November 1, 2022

ADDENDUM 2

Walnut Valley Unified School District
Diamond Bar High School
Building 400 Modernization New Classrooms/Library Media
DSA #03-121330 | File #19-H52

A10.11

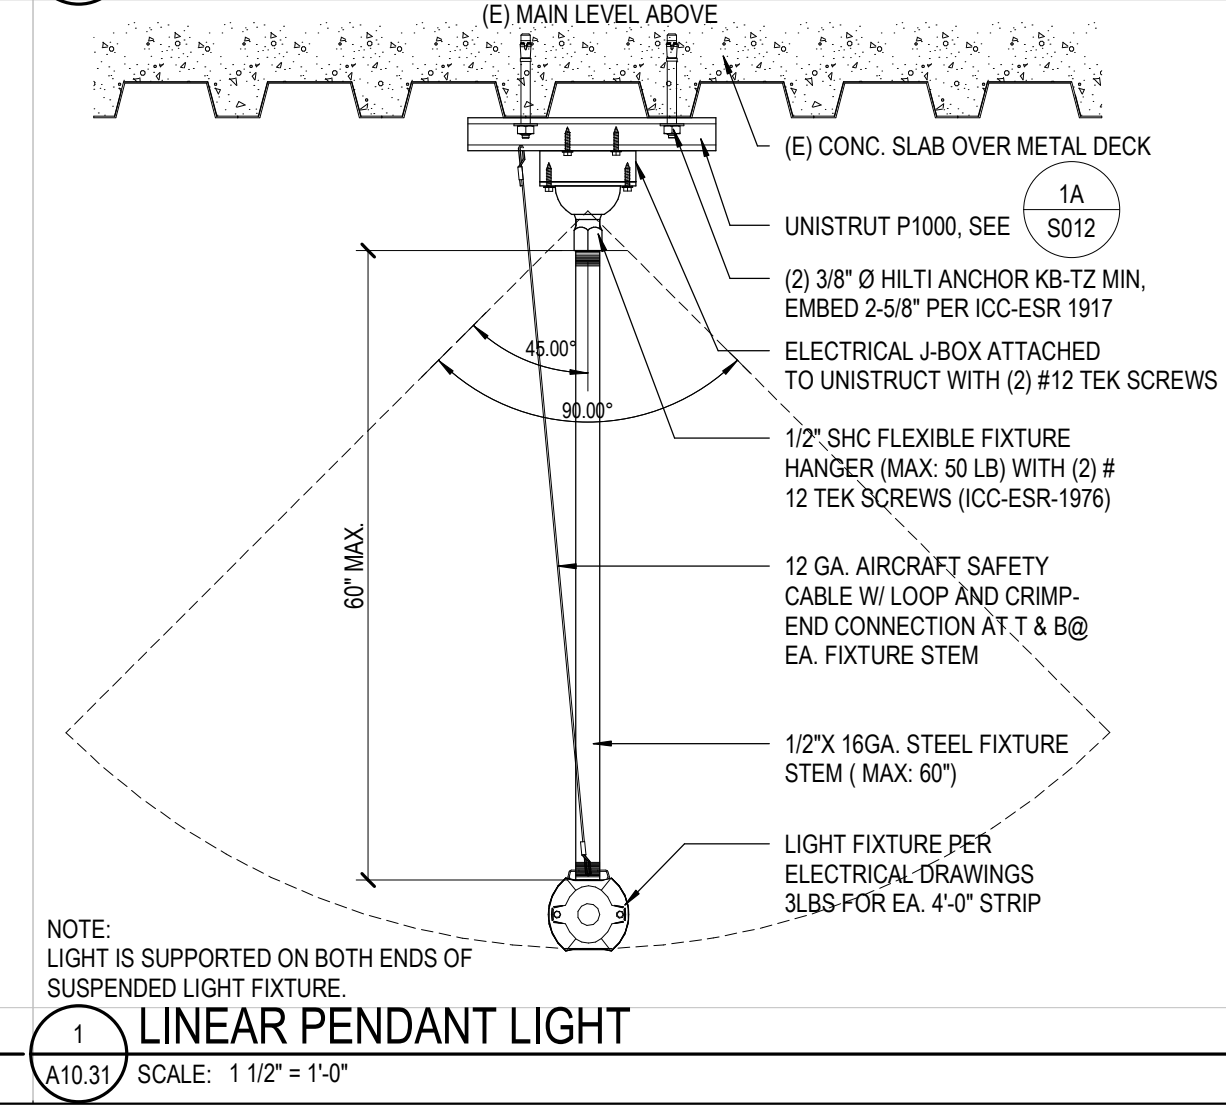
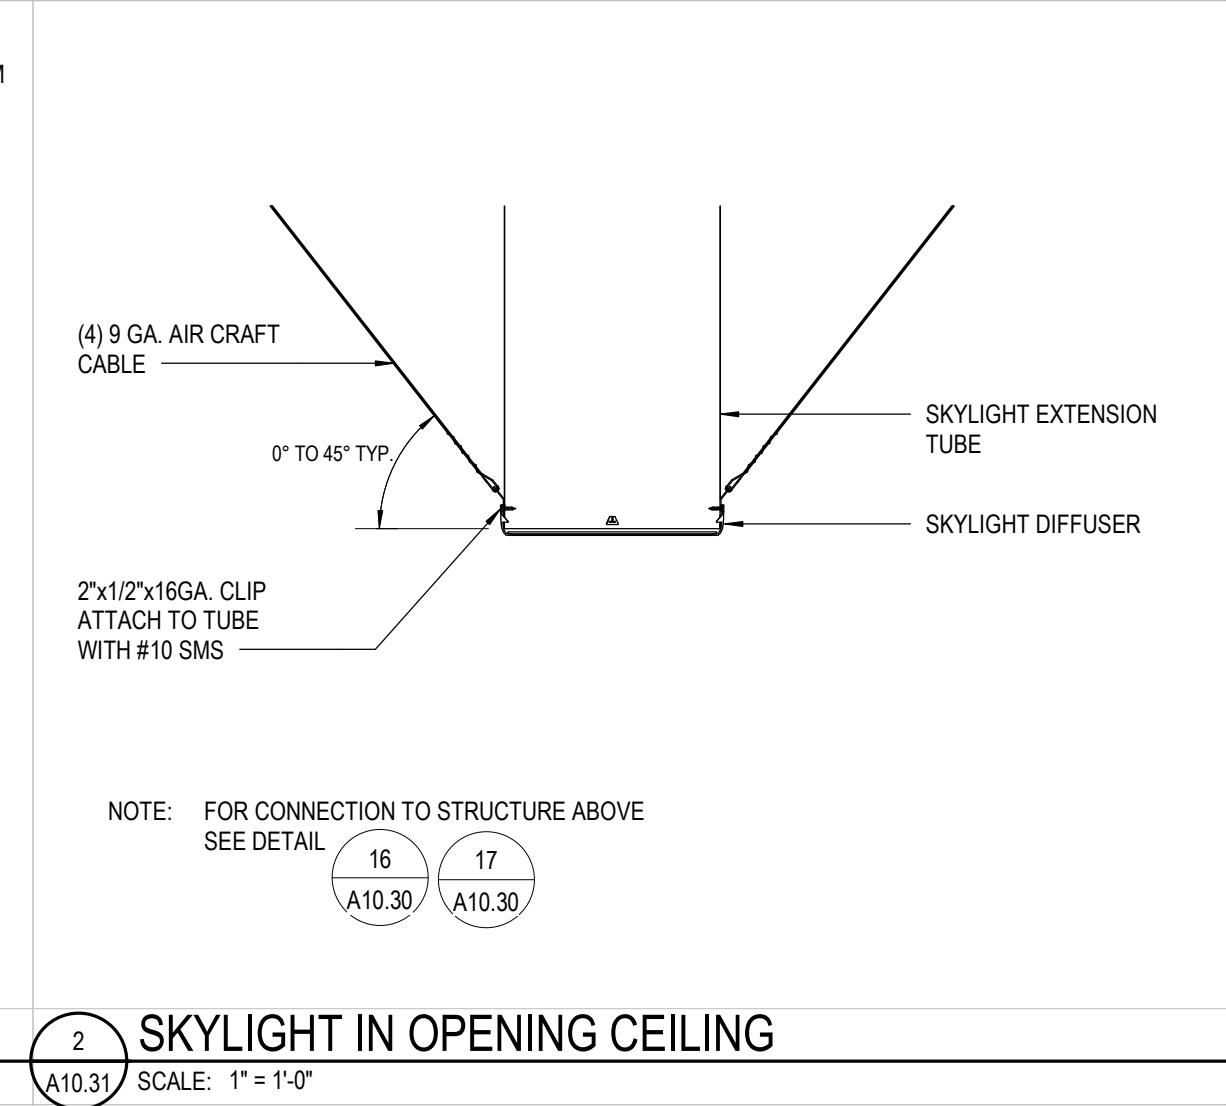
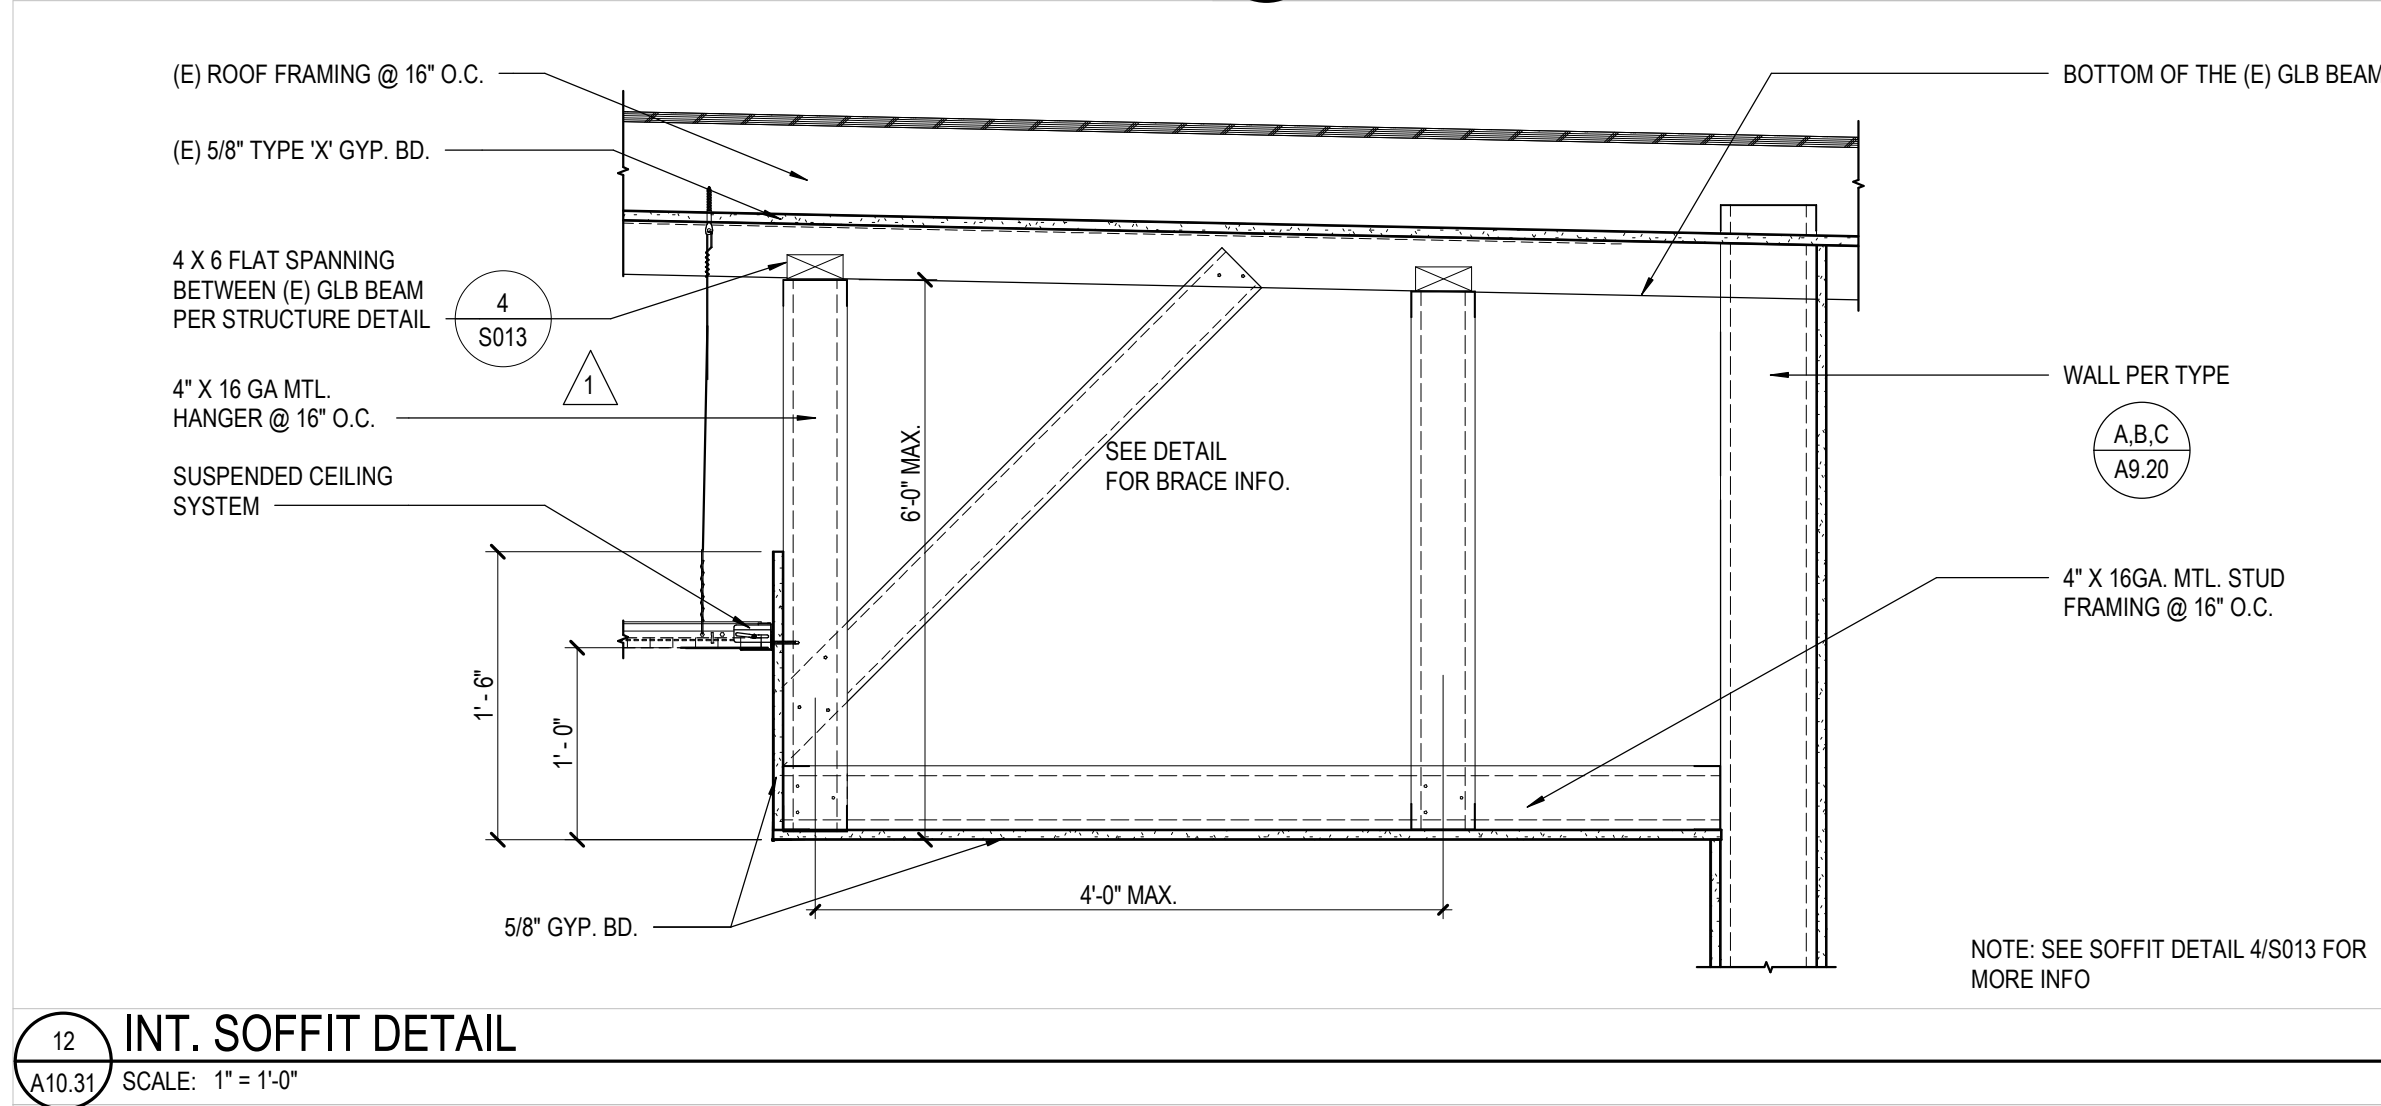
A10.11 INTERIOR DETAILS

- A. 23/A10.11: EDITED DETAIL TO DELETE THE HAND DRYER WHICH IS NOT USED IN THIS PROJECT
